Subject: Duke Energy Carolinas, LLC
Oconee Nuclear Site, Units 1, 2, and 3
Docket Numbers 50-269, 50-270, and 50-287
Request for Additional Information associated with the License Amendment
Request to Amend Technical Specification Required Action to Permit
Replacement of the 230 kV 125 Volt Switchyard Batteries
License Amendment Request No. 2006-20

Enclosure:
Request For Additional Information Response

RAI Responses

One-line schematic of the switchyard 125 Volt Direct Current (VDC) System (O-802)

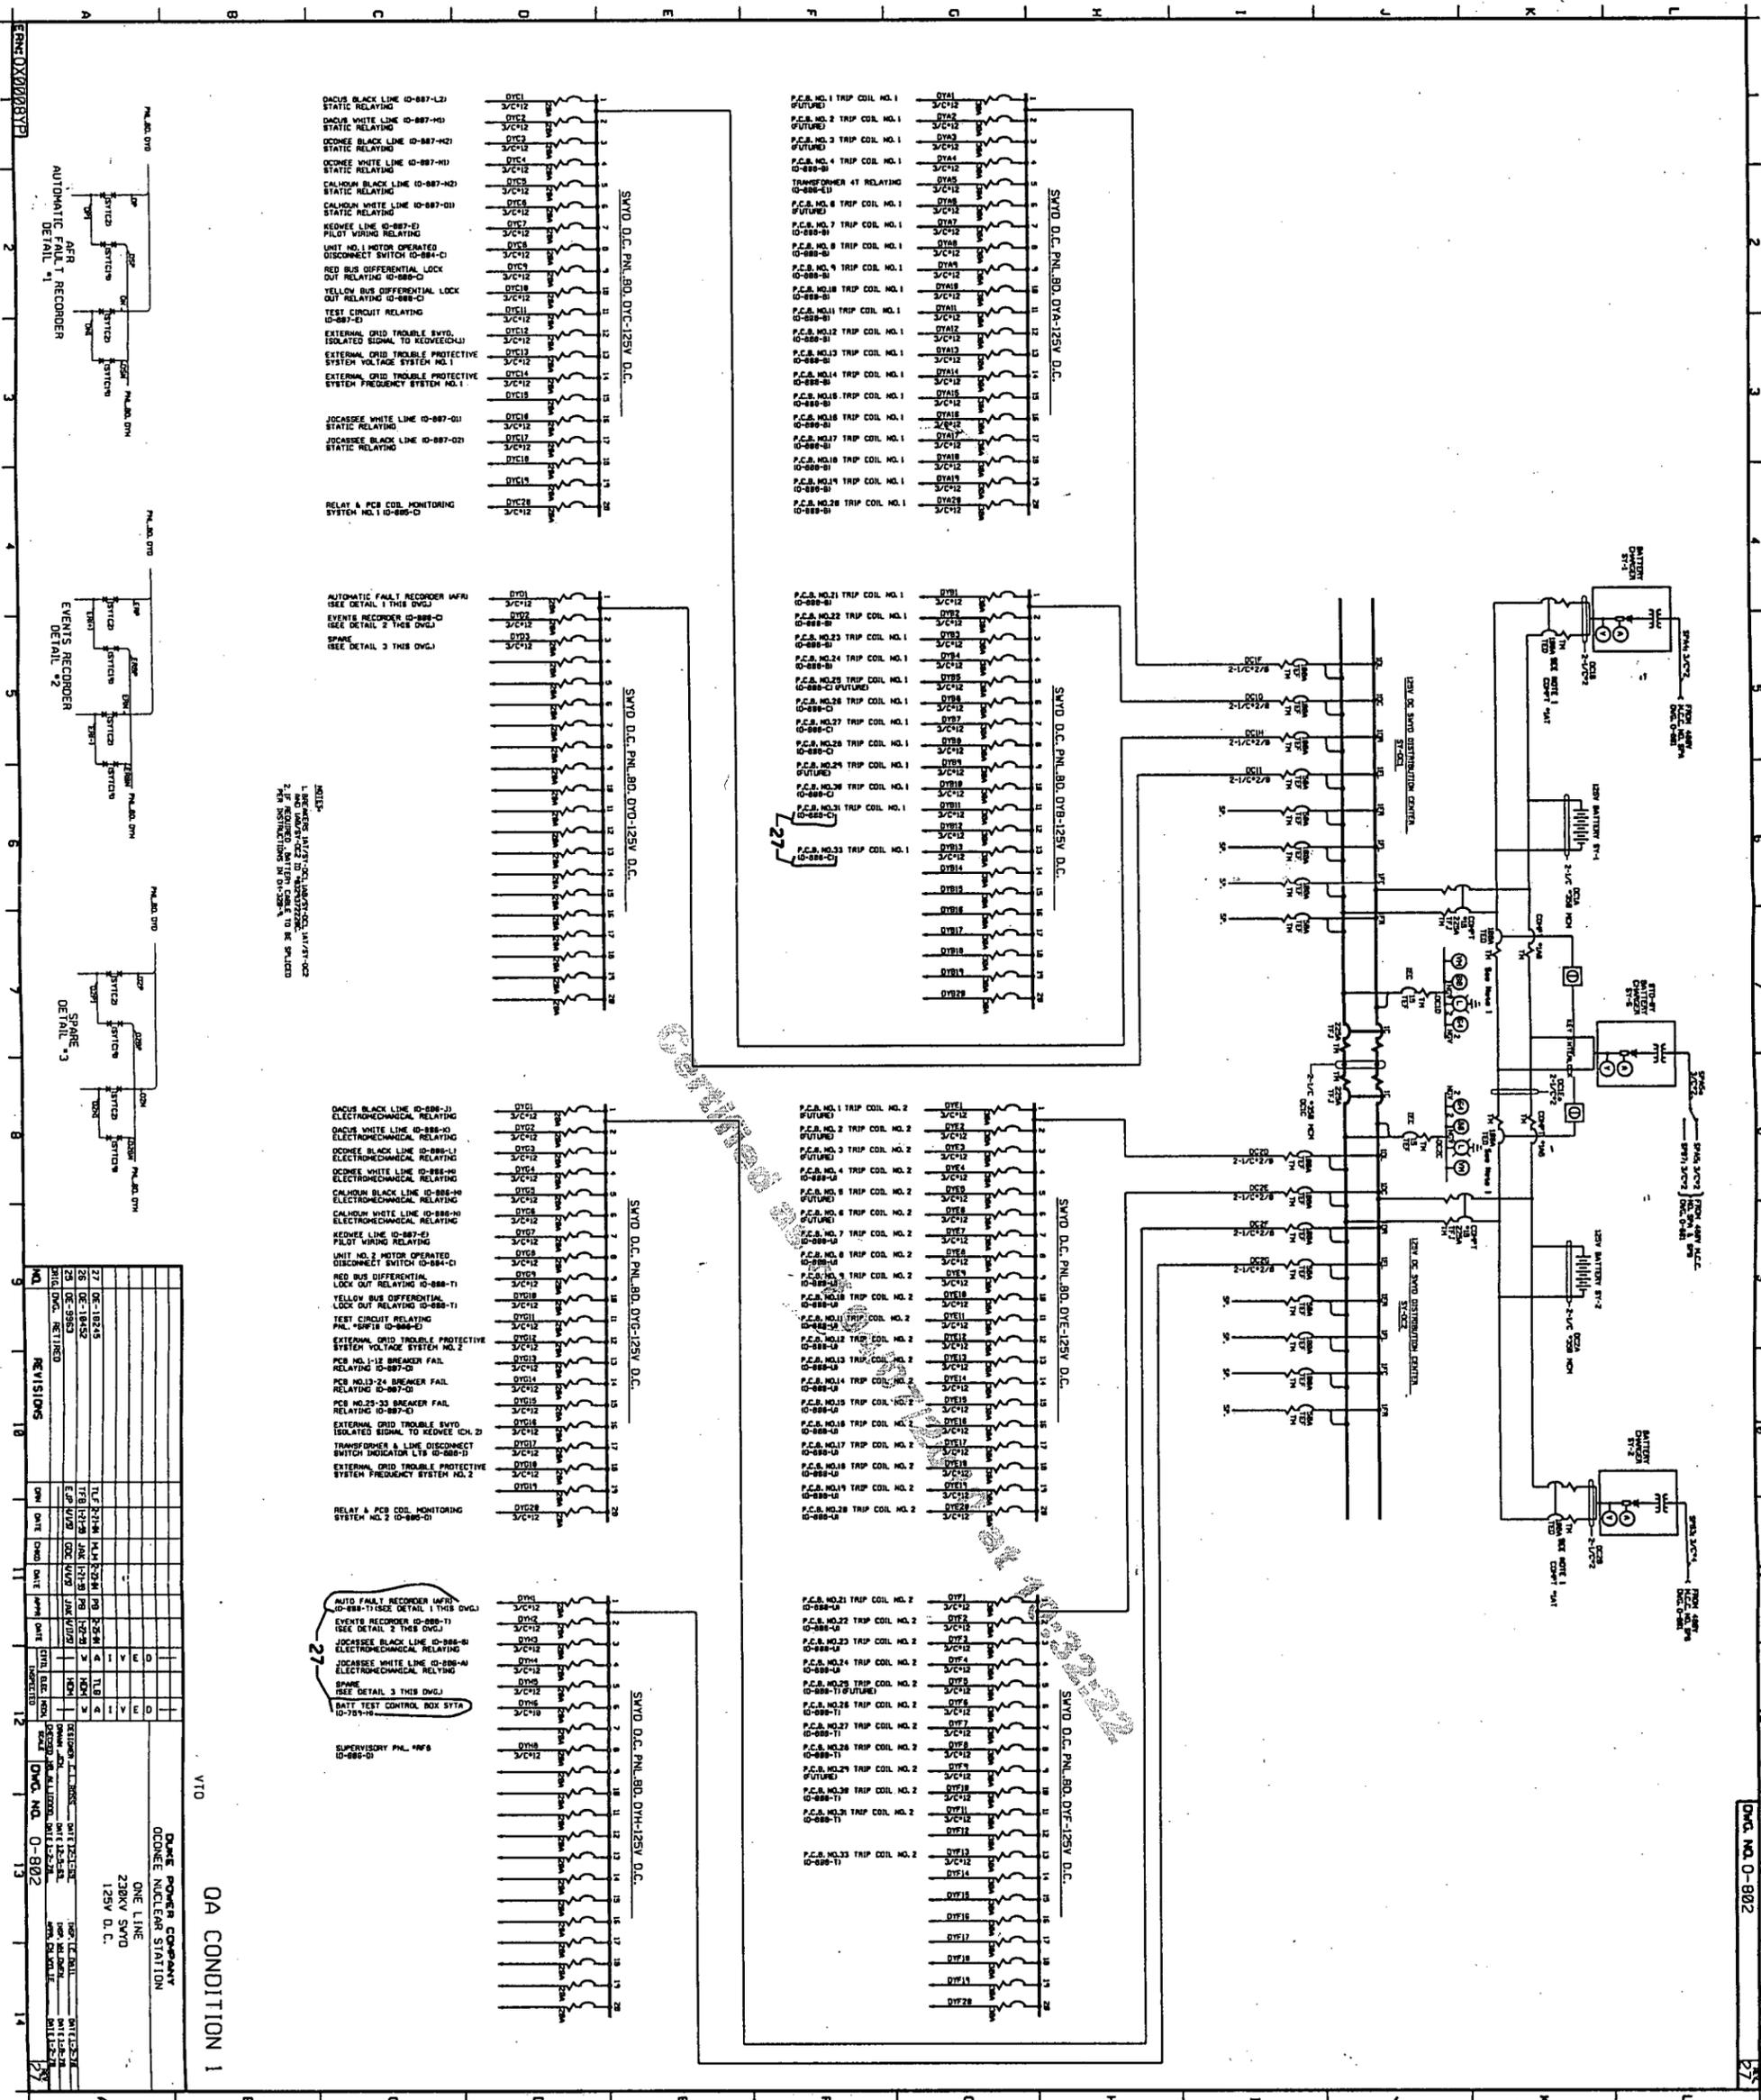
Provide a simplified one-line schematic of the switchyard 125 Volt Direct Current (VDC) system in which the battery bank(s) will be replaced.

Attachment 1 contains a one-line schematic of the switchyard 125 Volt Direct Current (VDC) System
